CATHOLIC CENTRAL STEM ADDITION JSP21-44

Public hearing at the request of Catholic Central High School for Planning Commission's approval of revised Special Land Use Permit, Preliminary Site Plan, Woodland Permit and Stormwater Management Plan. The subject property is zoned R-4 One Family Residential, R-1 One Family Residential, and I-1 Light Industrial and is located in Section 18, west of Wixom Road and south of Twelve Mile Road. The applicant is proposing to construct a 54,545 square foot addition to the main school building to house their Science Technology Engineering and Mathematics (STEM) classrooms and labs. Existing parking areas would be reconfigured.

PLANNING REVIEW

Review Date: November 30, 2021
Review Type: Preliminary Site Plan
Project Name: **JSP 21-44 CATHOLIC CENTRAL STEM ADDITION**
Plan Date: November 5, 2021
Prepared by: Lindsay Bell, Planner
Contact: **E-mail:** lbell@cityofnovi.org; **Phone:** (248) 347-0484

SHEET NO. CE-4

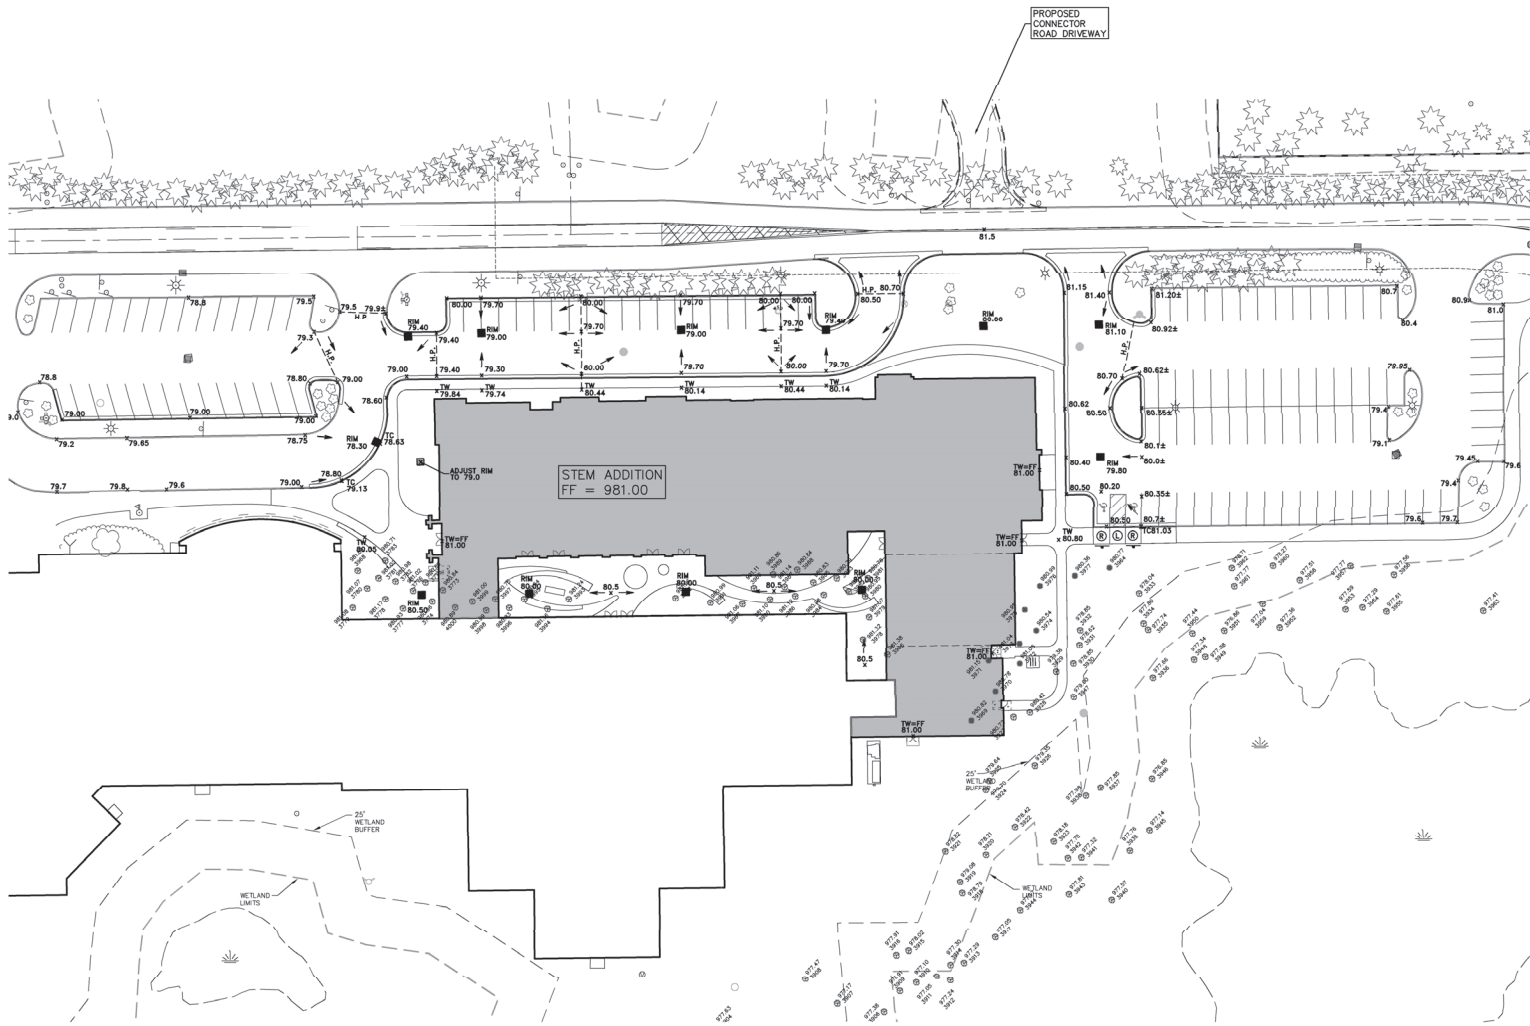
- 32-38. Sign type and location are included on Sheet CE-4. Additional sign location will be provided with Final Site Plan submittal.
- 39-41. Striping information will be included with Final Site Plan submittal.

- A Performance Turning Analysis has been added to this submittal that illustrates that an unobstructed outside turning radius of 50 feet minimum and an inside turning radius of 30 feet maximum are provided at the intersections of the roads. See Sheet CE-4.

PROJECT NO. 19120.2
SHEET NO. CE-8

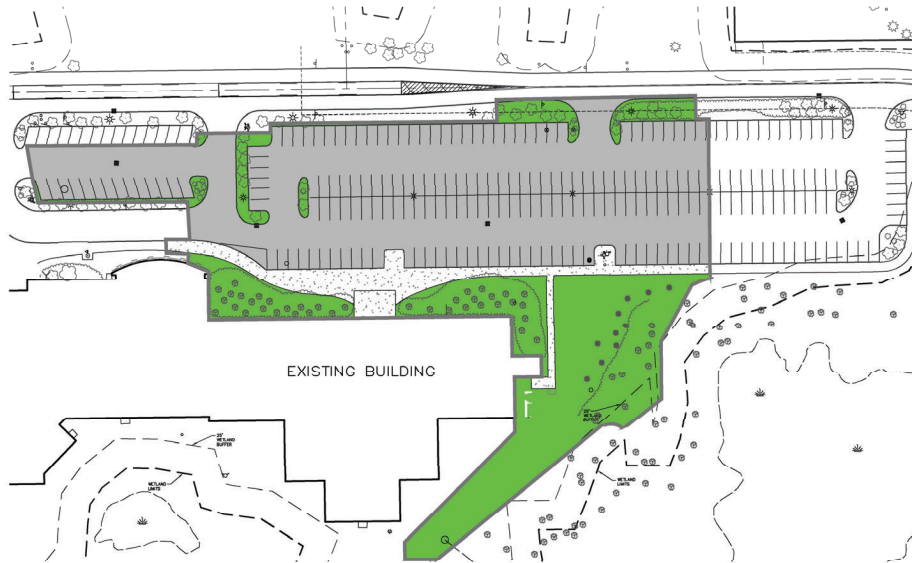
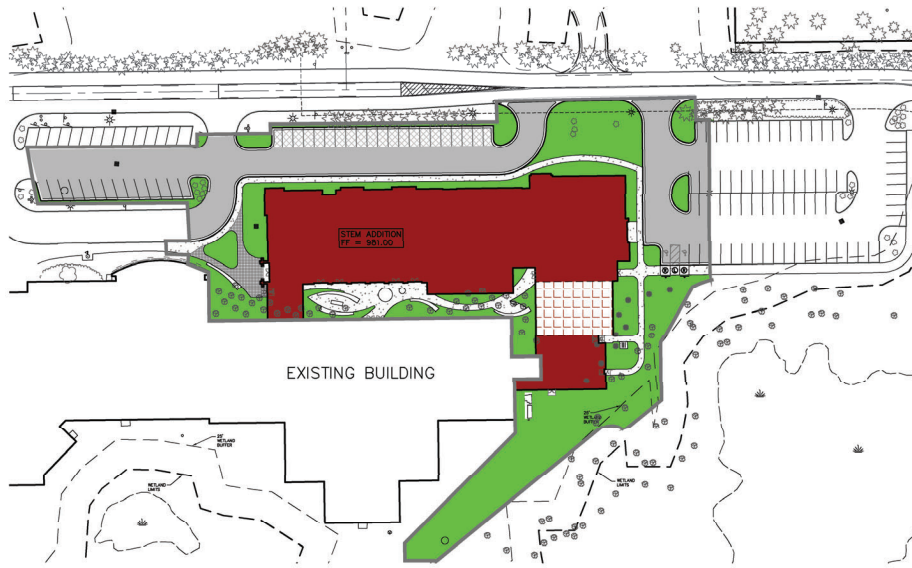
Sheet CE-8, *Drainage Conditions Plan*, of the PSP appears to depict a portion of the wetland buffer will be permanently maintained as lawn. MSG recommends the permanent buffer impact areas be minimized and the buffer be naturalized as much as possible to maintain the efficacy of the buffer in protecting the wetland from runoff from lawn areas (fertilizers, pesticides, etc.) and parking lots (oils, greases, salts, etc.).

1. **The extent of temporary and/or permanent impact to the wetland buffer must be quantified on the plan set.** The extents of temporary and/or permanent impacts will be provided for in the next submittal
2. **Sheet CE-8, *Drainage Conditions Plan*, of the PSP appears to depict a portion of the wetland buffer will be permanently maintained as lawn. MSG recommends the permanent buffer impact areas be minimized and the buffer be naturalized as much as possible to maintain the efficacy of the buffer in protecting the wetland from runoff from lawn areas (fertilizers, pesticides, etc.) and parking lots (oils, greases, salts, etc.).** The impacted buffer will be revised to reflect a wetland buffer seed mix versus lawn.

Sheet Number: **L201**
 © Grissim-Metz-Andriese Associates, 2021

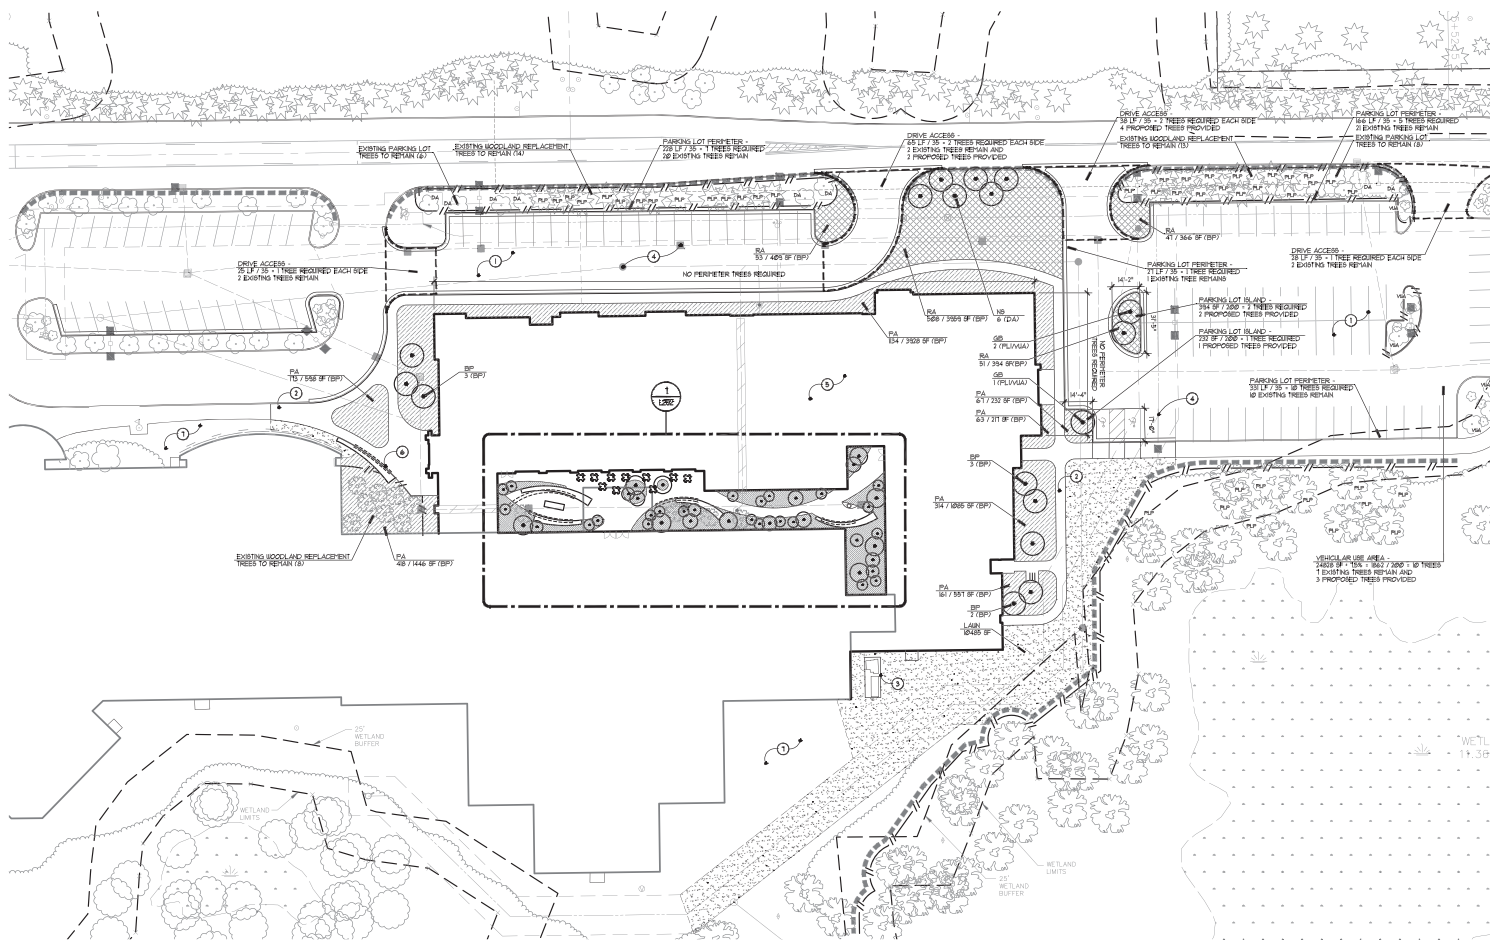
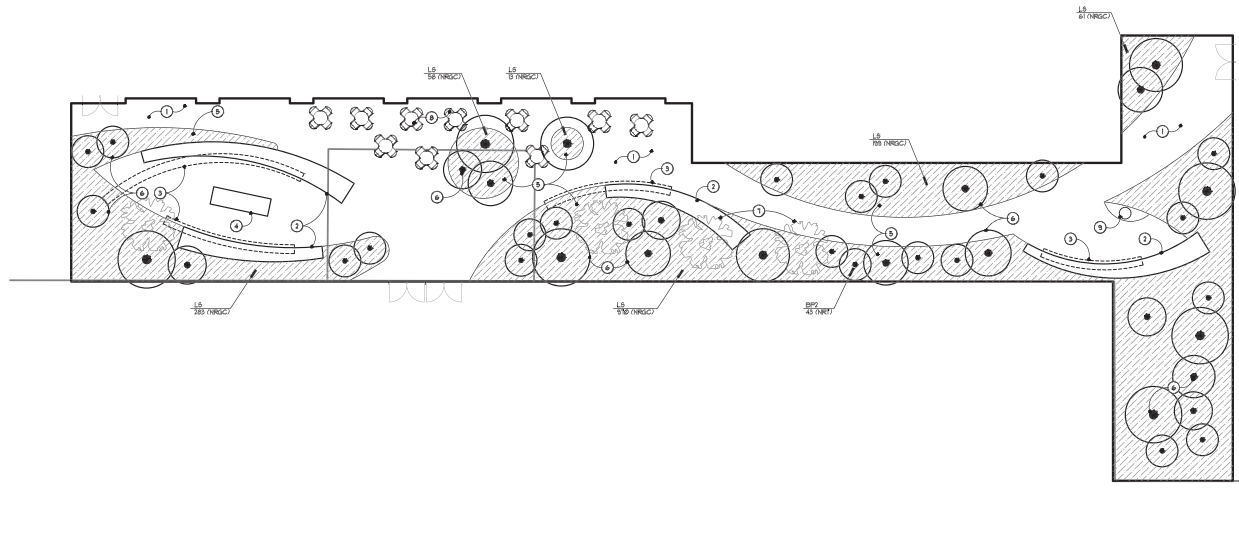
4. **Critical Root Zone.** The critical root zone and the location of tree protection fence of preserved woodland replacement trees in the new courtyard are not shown on the **sheets CE-7, L201, and L203** of the Preliminary Site Plan.

4. **Critical Root Zone. The critical root zone and the location of tree protection fence of preserved woodland replacement trees in the new courtyard are not shown on the sheets CE-7, L201, and L203 of the Preliminary Site Plan.**
